**IMPERIAL ROAD DESIGN MANUAL**  
**REVISIONS July, 2013**

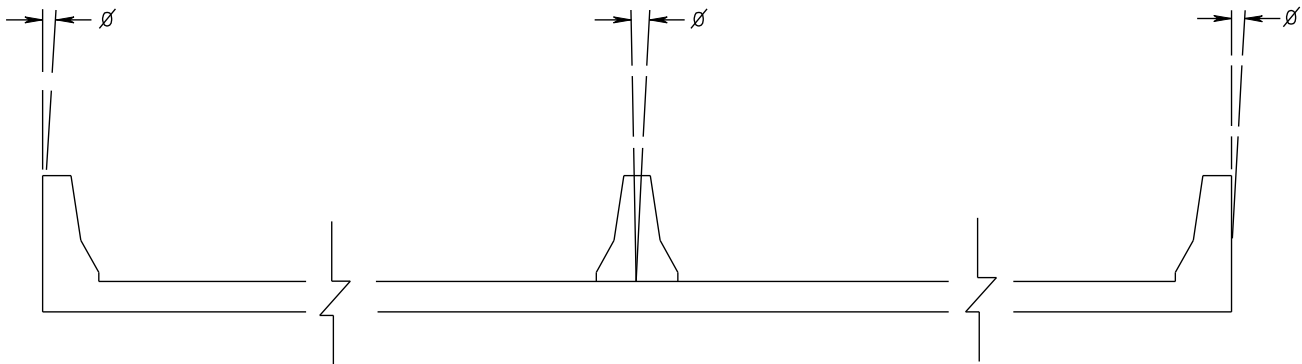
- Page 2E-25 & 26 – Relocated the following language to Appendix “A”;  
***POLICY FOR CONSTRUCTION OF CONCRETE BARRIER & RETAINING WALLS ON SUPERELEVATIONS***

- *Concrete Barriers on roadway approaches should be designed with the same shape (K type) and angle of inclination as the parapet face and concrete median barriers on the bridge.*
- *The Standard GS-11 has a 7% algebraic difference for the shoulder break on the outside of a superelevated section. The bridge deck has a straight super between parapet walls making it necessary to spline the shoulder grade of the roadway to match the bridge deck slope. Under normal conditions, this can be accomplished by a 200’ transition.*

*The same principle would apply to the low side of the roadway. Should the superelevation of the bridge deck be less than the slope of the inside shoulder, then it would be necessary to spline the shoulder grade to match the bridge deck. The length of transition is to be obtained by using sound engineering practices.*

- *When concrete barriers are tied into the bridge parapets and median, a general note will need to be included in the plans specifying:*

<i>“The Contractor is to transition the Concrete Barrier so that the face will align with the face of the bridge parapets and median.”</i>
--------------------------------------------------------------------------------------------------------------------------------------------

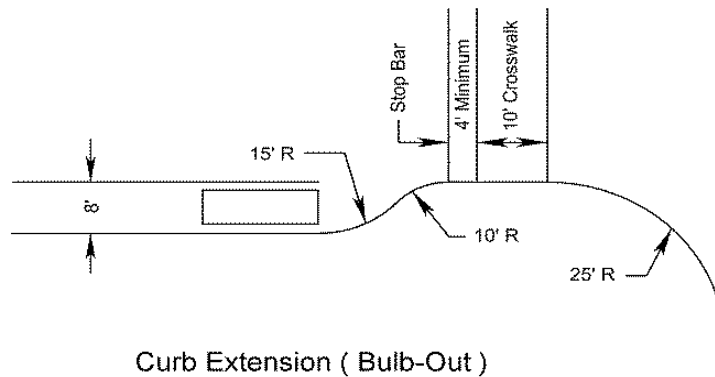
- Page B(1)-57 – Revised the following language in the third sentence in item “F” from;

Curb Extensions – Curb extensions at intersections are frequently used in Traditional Neighborhood Developments. Curb Extensions are usually found on higher volume streets where they are used to protect parking areas or reduce pedestrian crossing times. For intersections with curb extensions, a minimum 35’ radius should be used as in the sketch below. Intersection chokers or curb extensions can also be used to calm traffic and to shorten the distance pedestrians must travel to cross a street.

To;                    “*Curb Extensions – Curb extensions at intersections are frequently used in Traditional Neighborhood Developments. Curb Extensions are also used to protect parking areas and to reduce pedestrian crossing times.*”
